ADA Curb Ramp New Construction Inspection Form (Perpendicular)

WASHINGTON COUNTY OREGON

North-South Road Name	Project No.	Sheet No.	Intersection No.	East-West Road Name
Nw 288 ave	24952.54			Nw Shaddon st

PERPENDICULAR RAMP (PR)

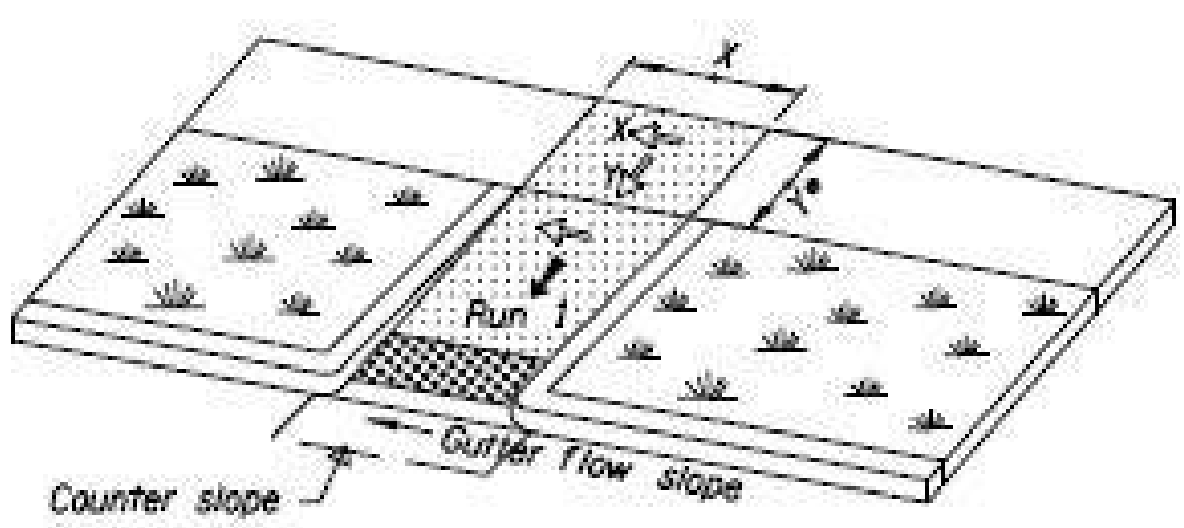
RAMP RUN 1	Value	Pass		Fail	
Running Slope 1		≤ 8.3%	☐	>8.3%	☐
Length 1	4.95				
Cross Slope 1		≤ 2.0%	☐	>2.0%	☐
Detectable Warning (Y,N)		Y	■	N	☐
Lip Height		1/4"	☐	>1/4"	☐
Gutter Flow Slope	0.5	≤ *	☐	>*	☐
Curb Running Slope (avg) (N/A ☐)	1.7	≤ 8.3%	☐	>8.3%	☐
Counter Slope (+/-) *2	3.7	≤|5.0%|	☐	>|5.0%|	☐
Longest distance from corner to back of curb (see dwg on BT form)		< 5.0'	■	≥ 5.0'	☐
Detectable warning extends full width of ramp throat opening		Y	■	N	☐

TURN SPACE ■ LANDING ☐ NONE ☐	Value	Pass		Fail	
Width X	6.1	≥ 4.0'	■	< 4.0'	☐
Length Y	5.0	≥ 4.0'*1	■	< 4.0'*1	☐
Back of Ramp Obstruction (Y/N)		≥ 5.0'*1	☐	< 5.0'*1	☐
Slope X		≤2.0%	☐	>2.0%	☐
Slope Y	2.6	≤2.0%	☐	>2.0%	■

MISCELLANEOUS	Traversable	Value	Pass		Fail	
Flare Slope 1	■		≤ 10%	■	< 10%	☐
Flare Slope 2	■		≤ 10%	■	<10%	☐
Clear Width (feet)			≥ 4.0'	☐	< 4.0'	☐
Intersection Control Type		MB	Slope of Road	0.2		
Horizontal Gaps			≤1/2"	☐	> 1/2"	☐
